The Commission has issued the enclosed Amendment Nos. 97 and 101 to Facility Operating License Nos. DPR-24 and DPR-27 for the Point Beach Nuclear Plant, Unit Nos. 1 and 2. The amendments consist of changes to the Technical Specifications in response to your application dated June 4, 1976 as modified January 28, 1980, and October 7, 1983 and revised December 20, 1984 and April 12, 1985.

POINT BEACH NUCLEAR PLANT, UNIT NO. 1

Amendment No. 97  
License No. DPR-24

ATTACHMENT TO LICENSE AMENDMENTS NO. 97 AND 101  
TO FACILITY OPERATING LICENSE NO. DPR-24 AND DPR-27  
DOCKET NOS. 50-266 AND 50-301

Figure 1. Point Beach liquid radwaste treatment and discharge pathways.

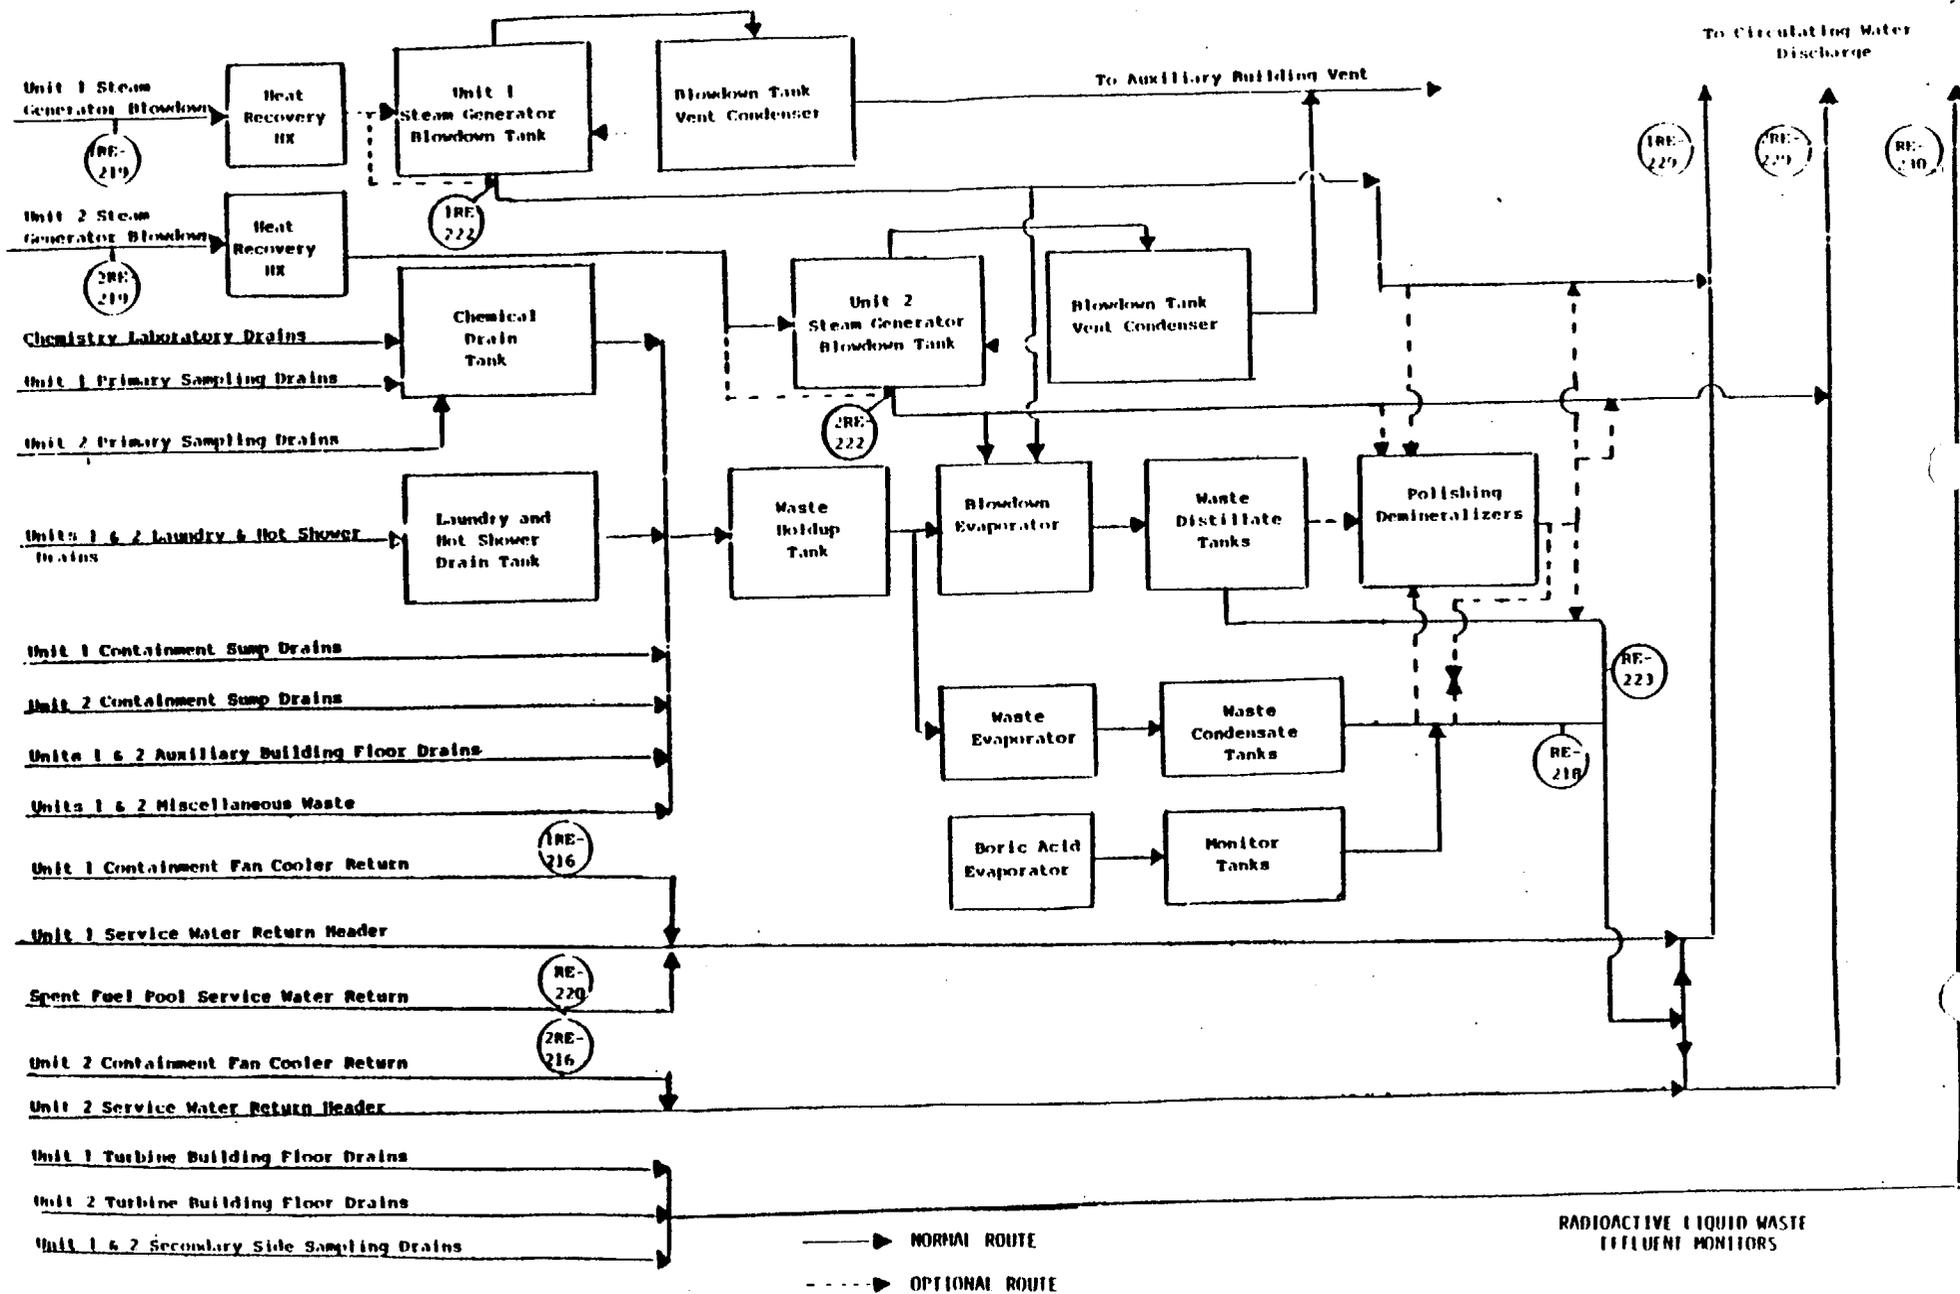
There are three release points for radioactive liquids to the circulating water discharge and each release point is provided with a radiation monitor. Additionally monitors are provided at significant locations upstream from these release points as shown in Figure 1. Stream flows are determined from instrumentation or pump curves. Thus, instrumentation is provided for all significant radioactive liquid release points with acceptable surveillance performed on the monitoring system.

Figure 2. Point Beach gaseous radwaste treatment and discharge pathways.

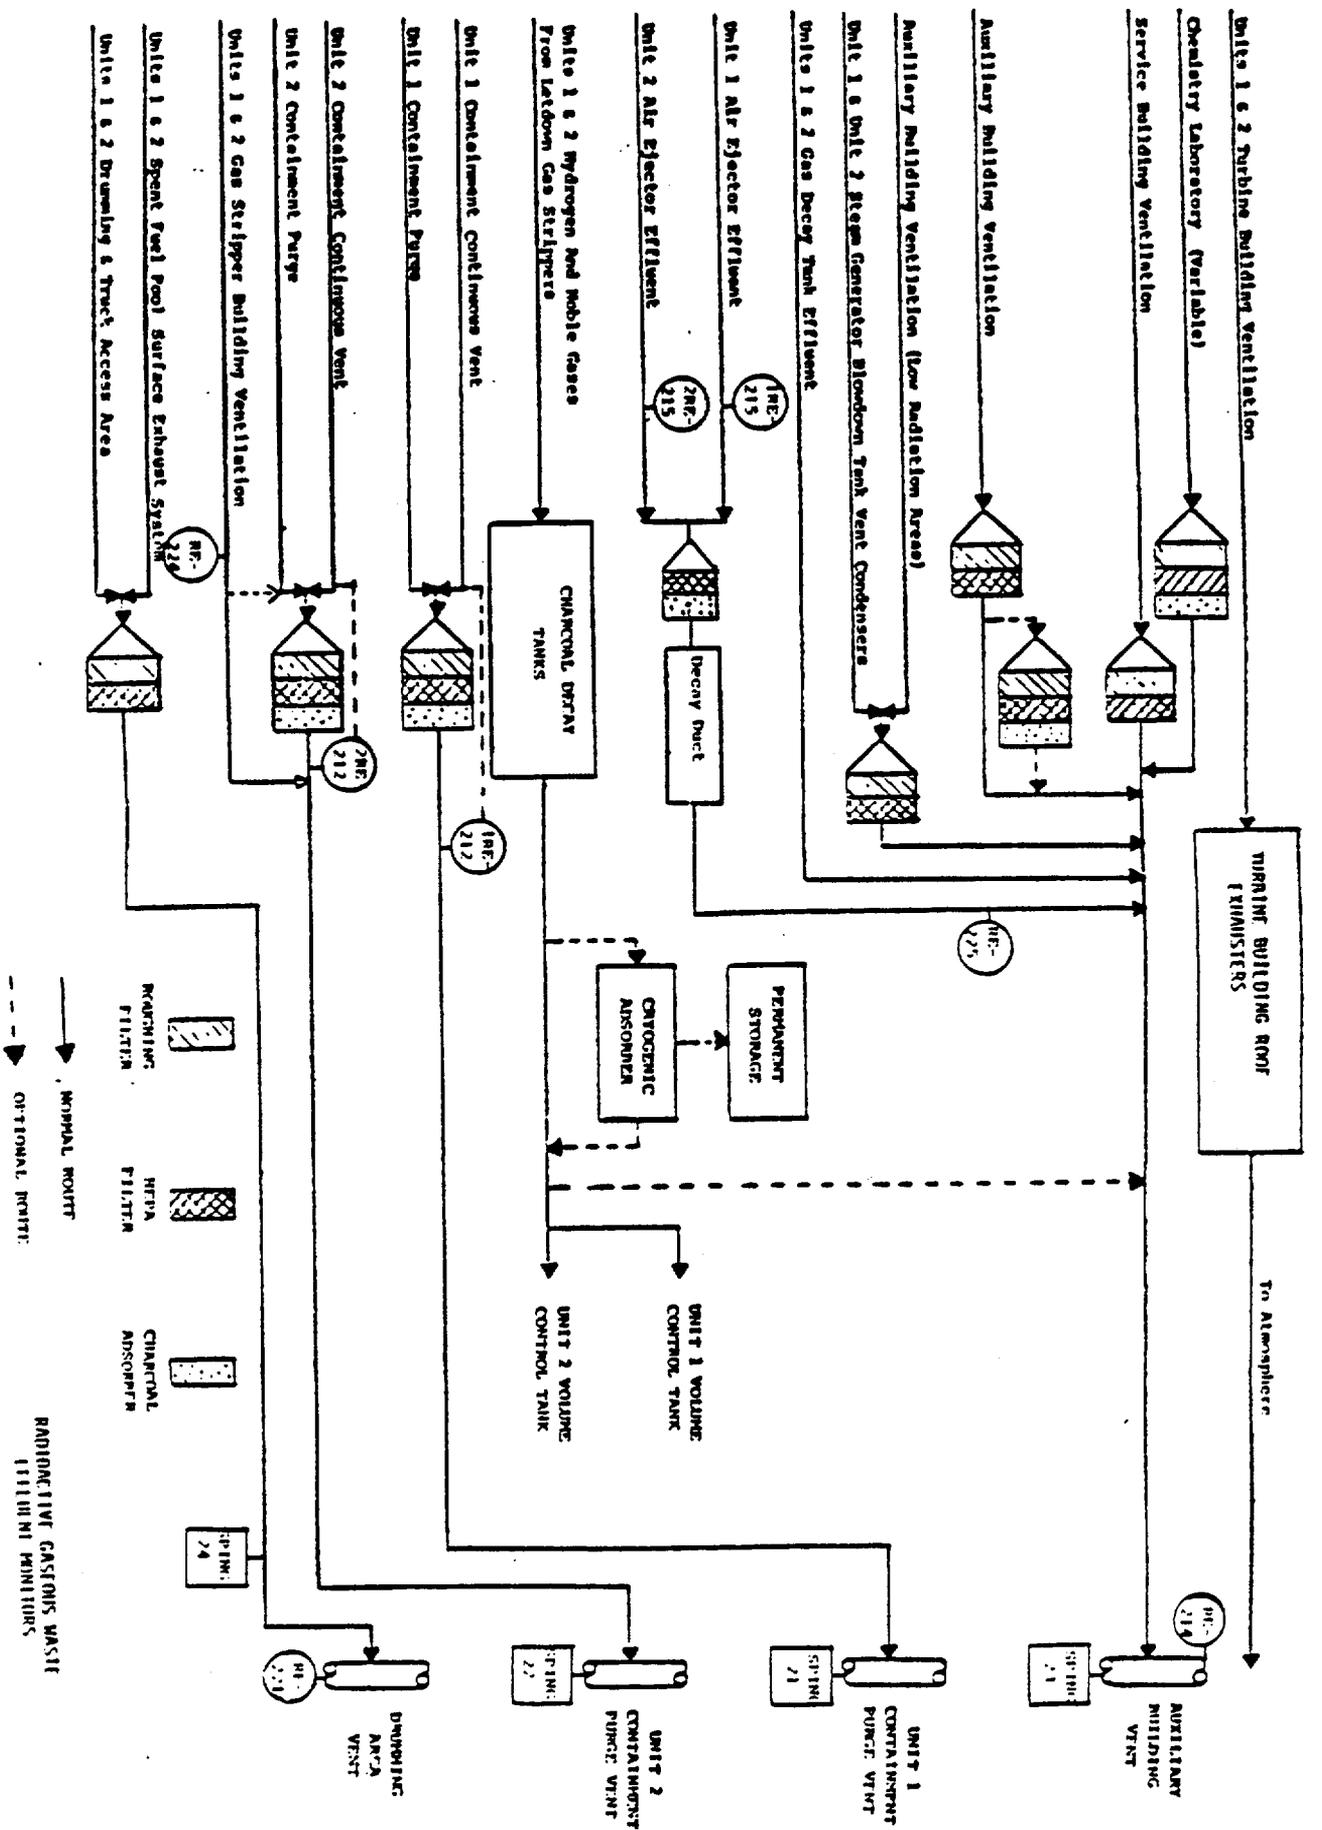
Radioactive gases are released to the atmosphere at four release points. Each release point is provided with radiation monitors with additional monitors at significant locations upstream from the release points as shown in Figure 2. Noble gas and SPING monitors are located at each release point. Each monitoring system contains flow rate measuring devices and acceptable surveillance checks are performed on each system.
